**PECOS DISTRICT
CONDITIONS OF APPROVAL****RECEIVED**

OPERATOR'S NAME:	Cimarex Energy Co. of Colorado
LEASE NO.:	NM-01135
WELL NAME & NO.:	Southeast Lusk 33 Federal #3
SURFACE HOLE FOOTAGE:	025' FNL & 2460' FEL
BOTTOM HOLE FOOTAGE:	330' FSL & 1980' FEL
LOCATION:	Section 33, T. 23 S., R. 32 E., NMPM
COUNTY:	Lea County, New Mexico

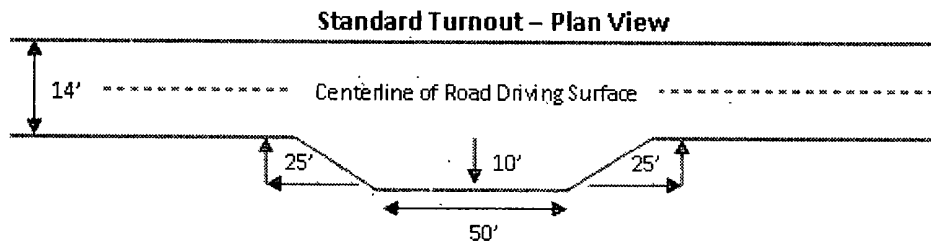
Vehicle turnouts shall be constructed on the road. Turnouts shall be intervisible with interval spacing distance less than 1000 feet. Turnouts shall be constructed on all blind curves. Turnouts shall conform to the following diagram:

Cross Section of a Typical Lead-off Ditch

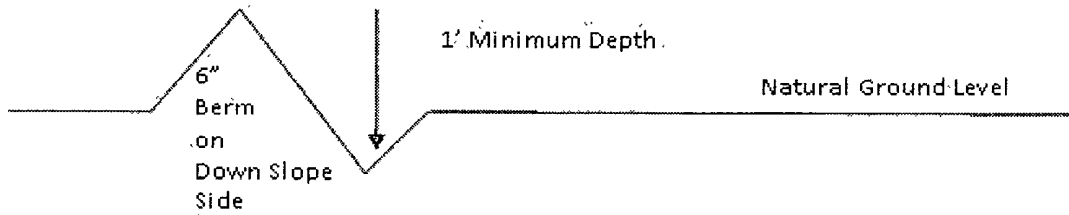
A typical lead-off ditch has a minimum depth of 1 foot below and a berm of 6 inches above natural ground level. The berm shall be on the down-slope side of the lead-off ditch.

All lead-off ditches shall be graded to drain water with a 1 percent minimum to 3 percent maximum ditch slope. The spacing interval are variable for lead-off ditches and shall be determined according to the formula for spacing intervals of lead-off ditches, but may be amended depending upon existing soil types and centerline road slope (in %);

Figure 1 – Cross Sections and Plans For Typical Road Sections

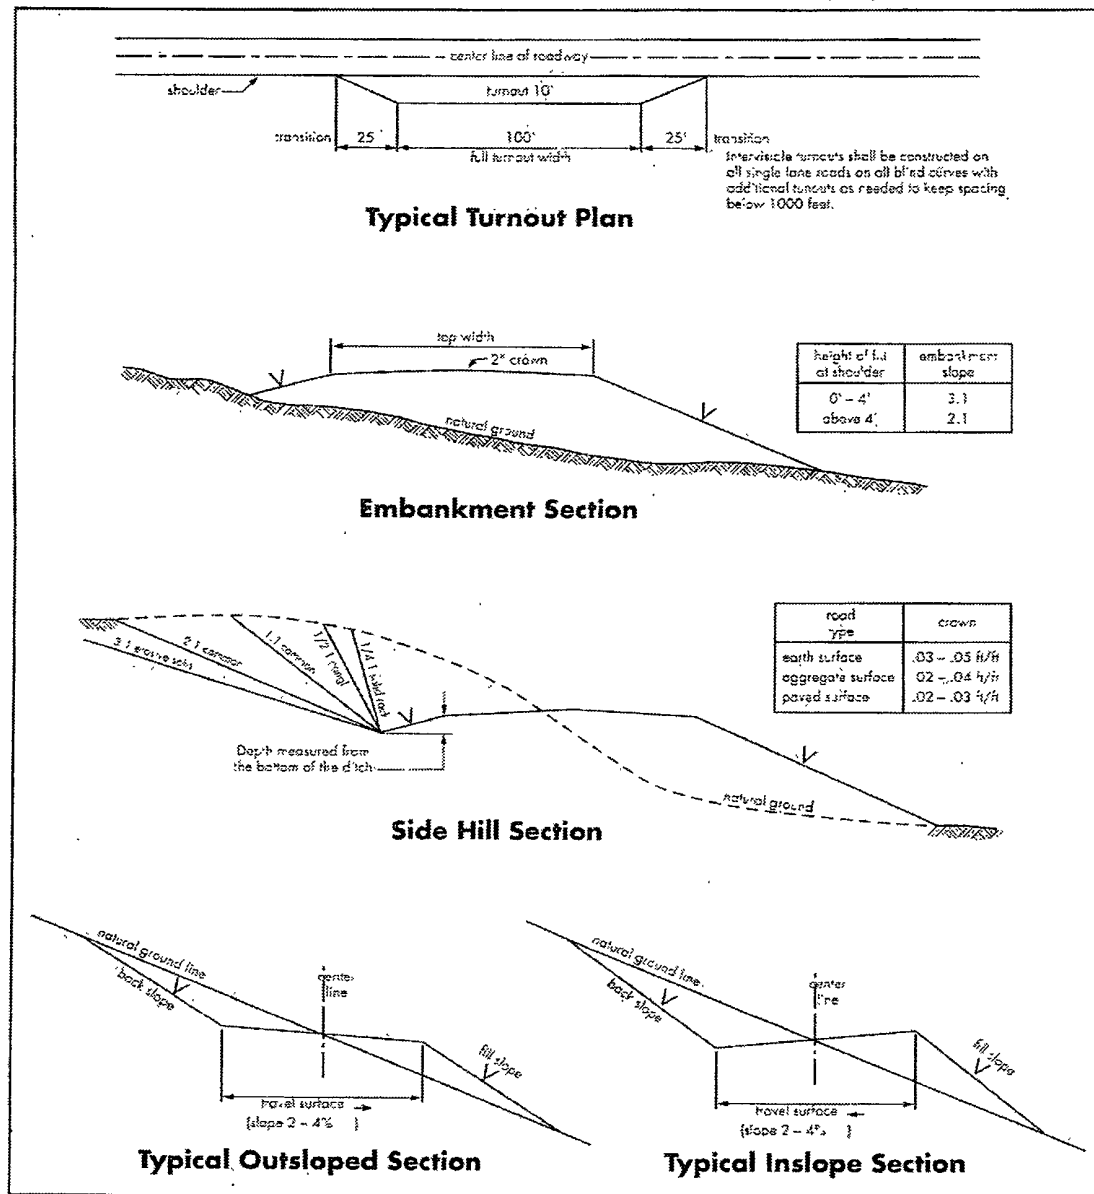
Crowning shall be done on the access road driving surface. The road crown shall have a grade of approximately 2% (i.e., a 1" crown on a 14' wide road). The road shall conform to Figure 1; cross section and plans for typical road construction.
